Proposed Optical parameters for Clauses 182 and 183 in support of D1.2 comments #146 and 147.

802.3dj Nov 2024 Plenary Vancouver.

Introduction

Mission Mode: FECi vs. FECo BER vs. Rx_OMA

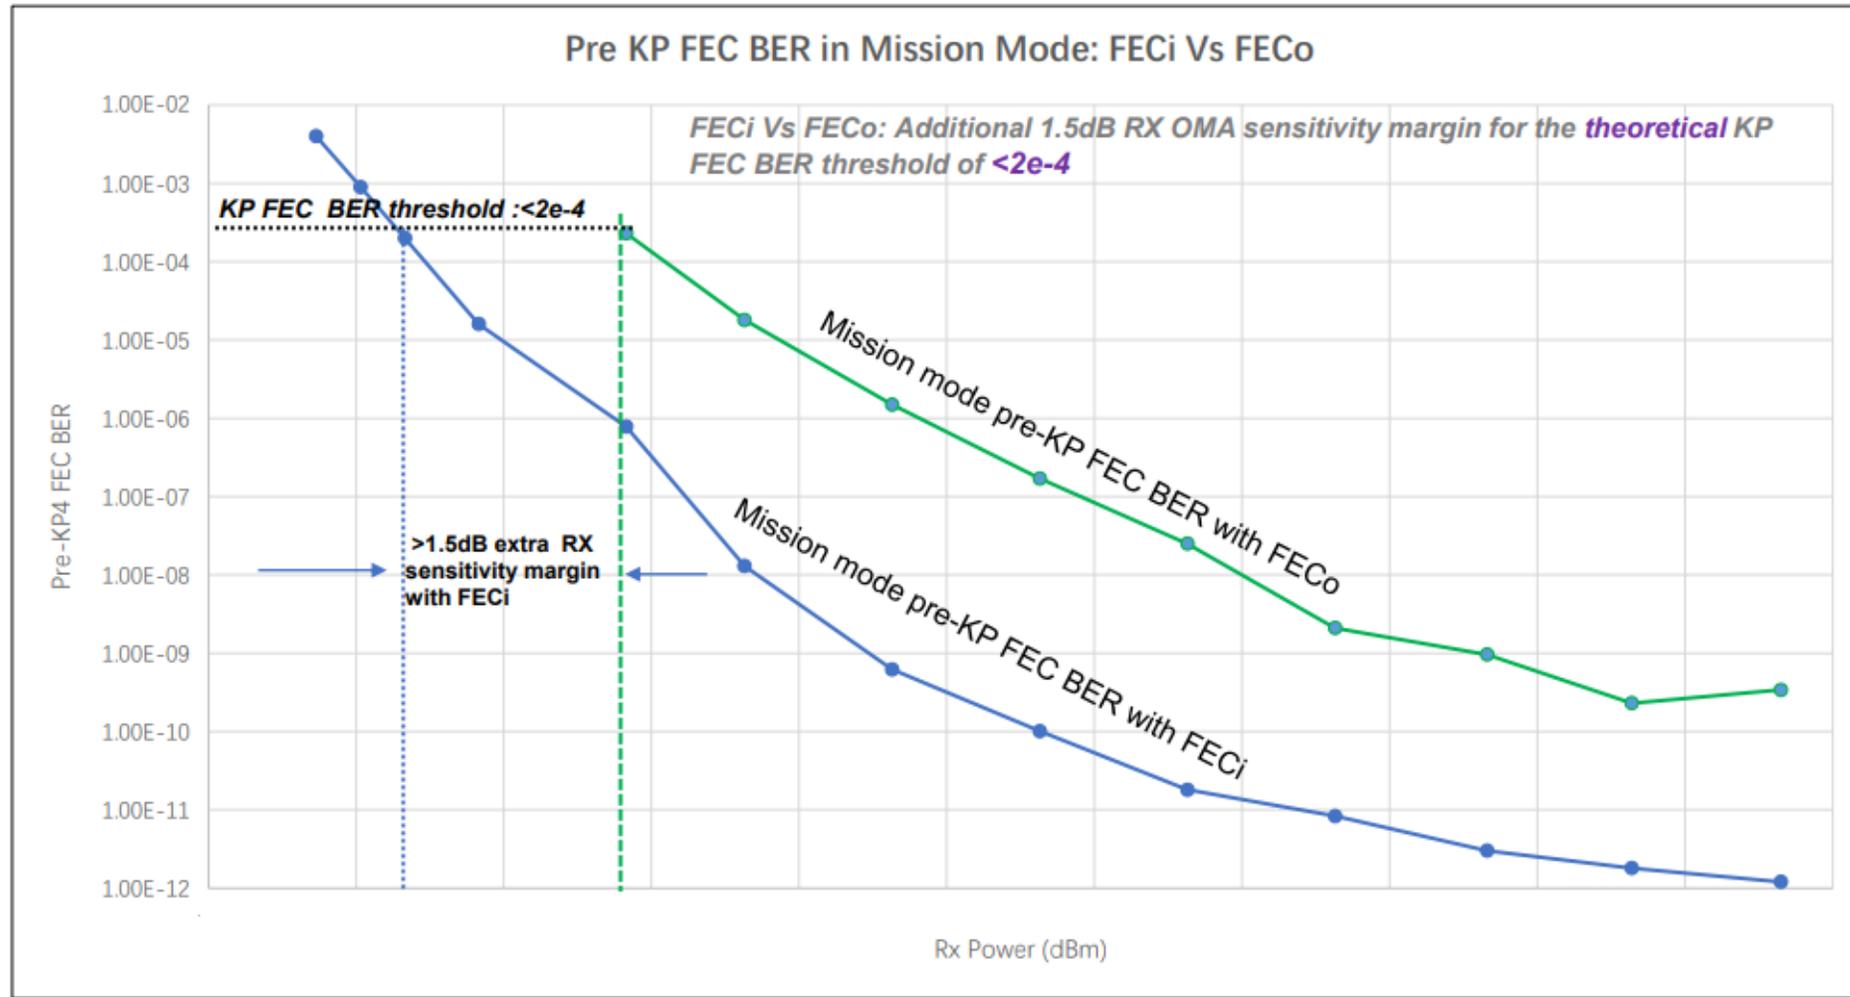
Justification for Optical output $\text{OMA}_{\text{outer}}$ – TDECQ (DR-2)

- The channel loss budget for the DR specifications is only 1dB larger for 2km versus 500m, and allocated additional penalties for DGD and MPI is 0.4dB at 2km versus 0.1dB at 500m.
- The existing D1.2 spec is requiring the 2km DR specs to have an extra 0.7dB output OMA and 0.6dB better receiver sensitivity.
- The 2km specifications use inner FEC which is shown to improve receiver sensitivity by >1.5dB in Yu_3dj_01b_2407([800G \(4x200G-PAM4\) Module Test Data with FECi and FECo \(ieee.org\)](#)) (see next slide)
- It is also likely that the effect of MPI and DGD will have smaller penalties with the inner FEC due to the higher allowed pre-FEC BER so the 0.4dB additional penalty above TDECQ is probably conservative.
- Asking for 0dB additional output OMA from the Tx and 1.3dB better sensitivity from the Rx is a better compromise than the existing draft 1.2 requirements.

Receiver sensitivity versus TDECQ with different SER

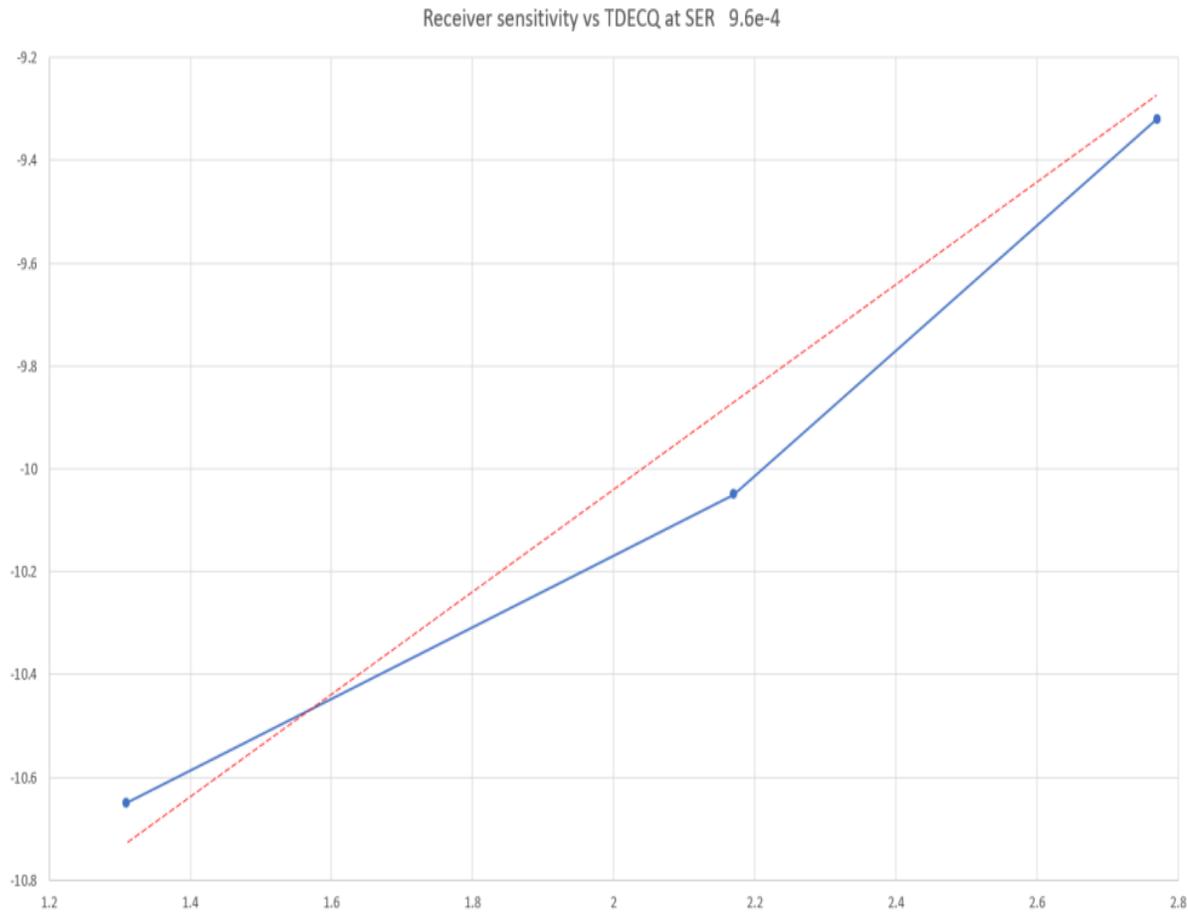
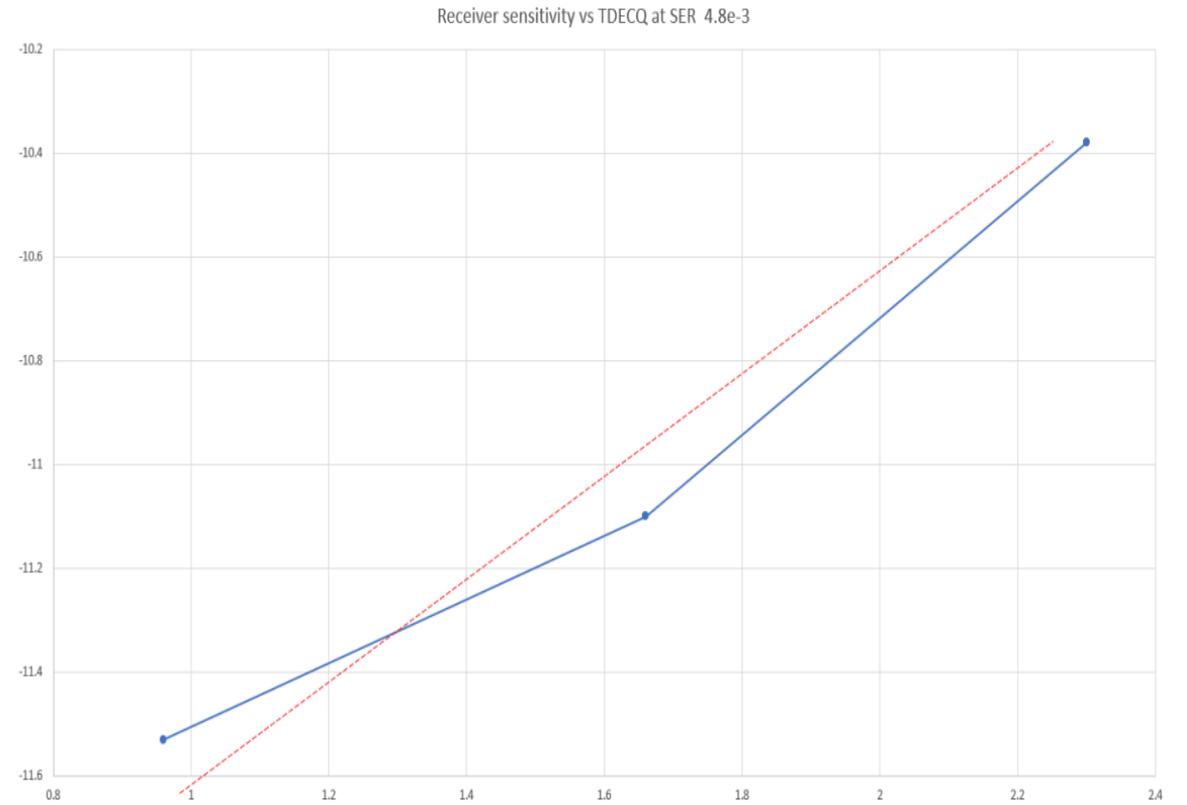
Justification for Maximum value of TDECQ/TECQ

- The max value of TDECQ/TECQ is currently TBD in D1.2 for the 2km specs
- Proposed value is the same as for the 500m specifications which is a reasonable value.
- No evidence has been shown that receivers would have problems with this high a value of SECQ(TECQ) at 200G. Evidence that this is not an issue at higher SER has been shown at 100G in [Study on the Dependence of TDECQ on SER \(ieee.org\)](#) (simulations) and [Physical measurements for TDECQ versus SER \(ieee.org\)](#) (practical measurements). See following slides for some examples of the measurements.
- Replacing a TBD with a reasonable number moves the project forward and there is plenty of time to refine the number later when more practical measurements are available.

Receiver sensitivity versus TDECQ with different SER (cont)

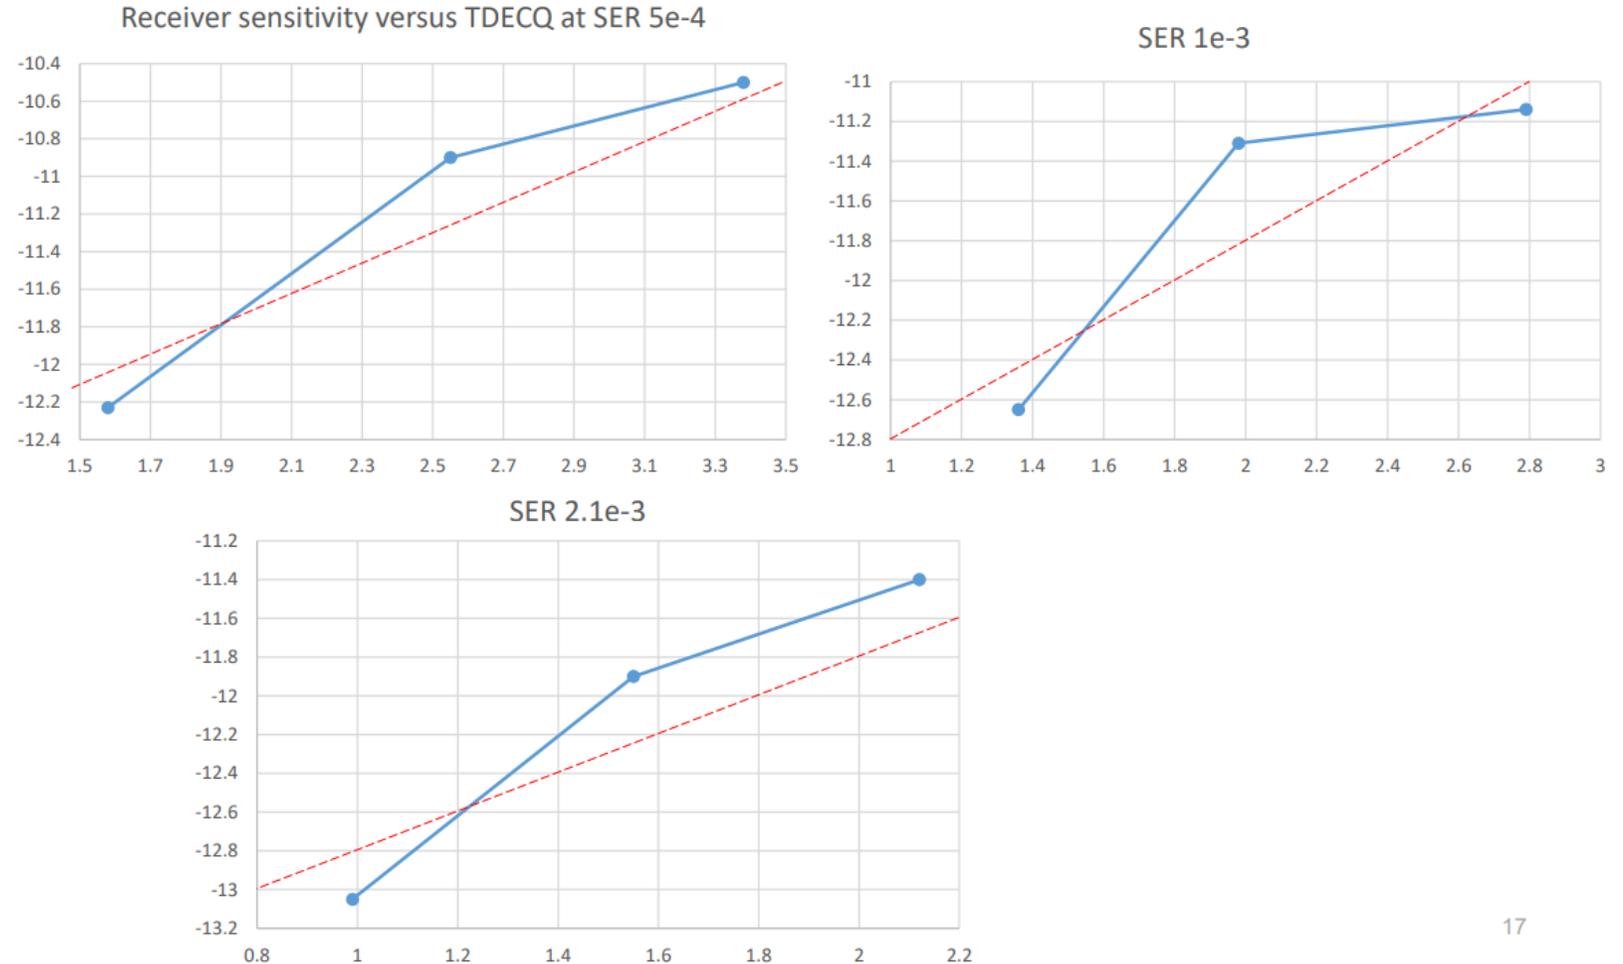
Experiment 3: Three FR4 EML transmitters with TDECQ range 1.5, 2.5, 3.5 (at SER 5e-4)

- 2.1e-3 highest observable SER

Receiver sensitivity versus TDECQ with different SER (cont 2)

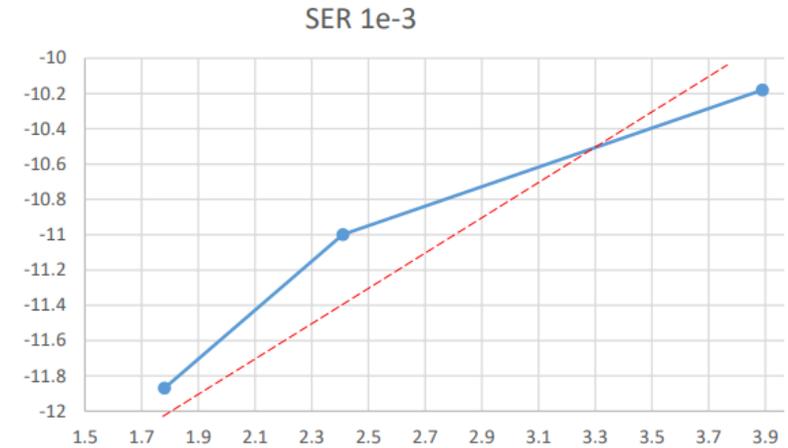
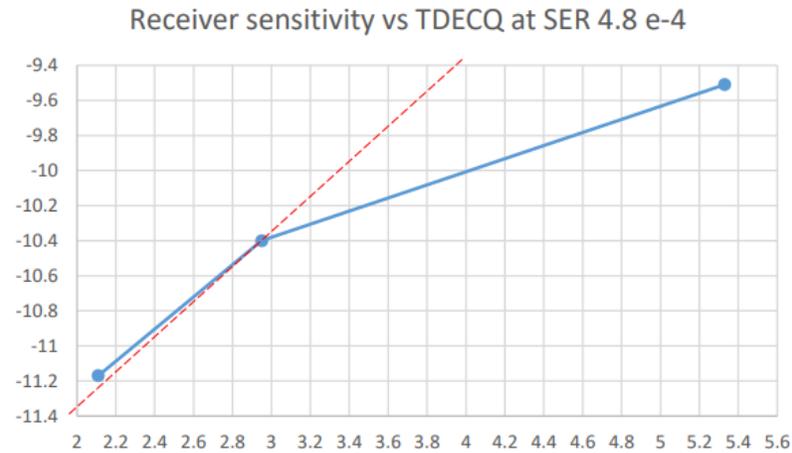
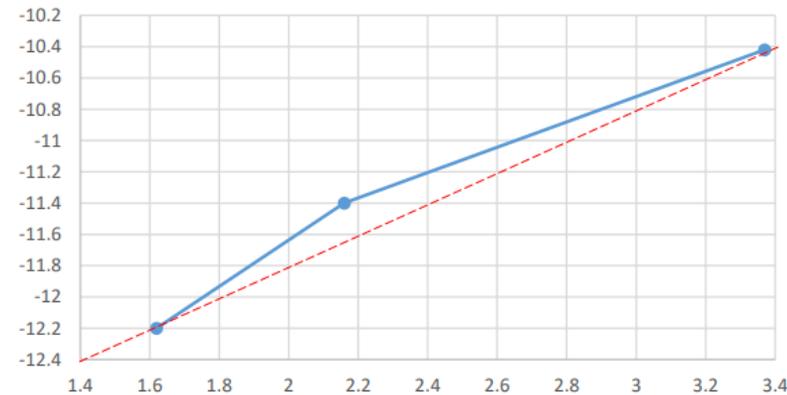
- TDECQ as high as 5.6 dB (at SER 4.8e-4) achieves a working link
- Very good correlation at SER 1.5e-3 (highest observable SER)

RX sens at SER 1.5e-3 (highest SER observable)

The effect of Chromatic dispersion on TDECQ and Receiver sensitivity

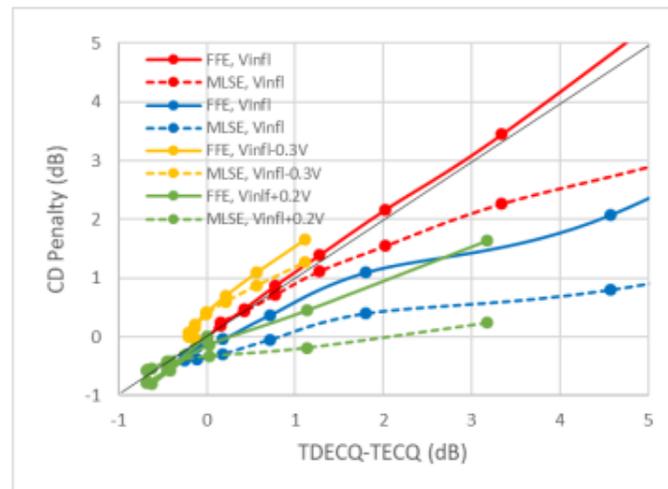
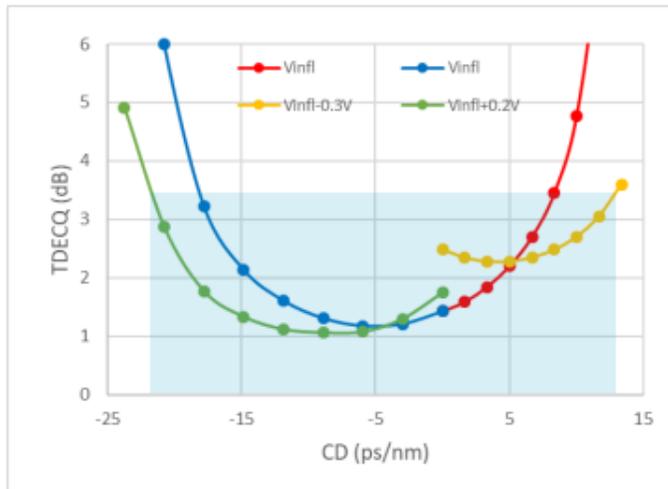
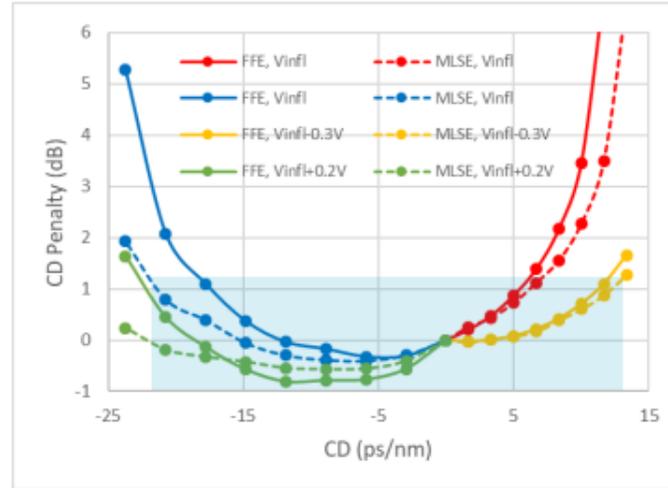
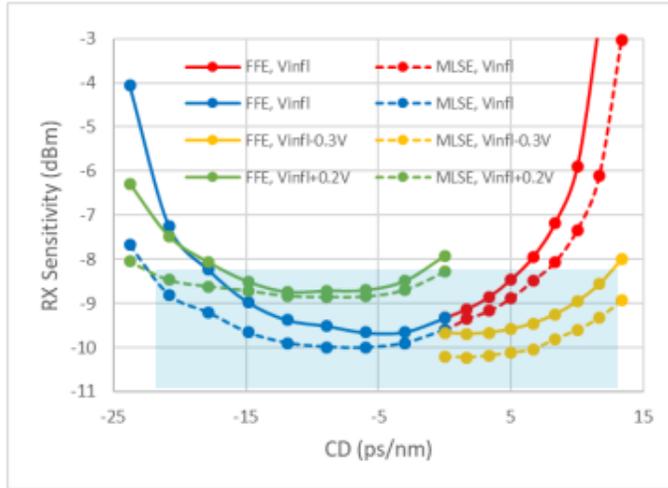
Justification for Maximum value of TDECQ/TECQ for 800GBASE-FR

- The max value of TDECQ/TECQ for 800GBASE is currently TBD in D1.2 for the 2km specs.
- Proposed value for TDECQ is the same as for the 500m specifications which is a reasonable value as discussed on slides 6 - 9.
- Johnson_3df_01a_221011([Chirp characteristics and chromatic dispersion tolerance of 200G EML transmitters \(ieee802.org\)](https://ieeexplore.ieee.org/document/9888888)) showed that chromatic dispersion effects on receiver sensitivity are no more severe than TDECQ predicts. i.e. TDECQ is either a good predictor or a conservative measurement depending on dispersion slope. See next slide.
- All other proposed values are direct calculations from the value of TDECQ/TECQ max or no change from draft 1.2
- Replacing a TBD with a reasonable number moves the project forward and there is plenty of time to refine the number later when more practical measurements are available.

- Biasing more negative for lower chirp is necessary to reduce TDECQ and CD Penalty for the 1330nm channel at 2km
- Biasing more positive for more positive chirp is less necessary for the 1270nm channel, but can improve TDECQ and CD Penalty at the expense of B2B Sensitivity
- TDECQ < 3.4dB is achieved over -21.5 to +12.8 ps/nm CD, supporting up to 3.5km CWDM transmission
- Using FFE+MLSE RX, through fiber Sensitivity < -8.3dBm and CD Penalty < 1.2 dB is achieved with this RX model
- TDECQ minus TECQ overestimates CD penalty for negative dispersion
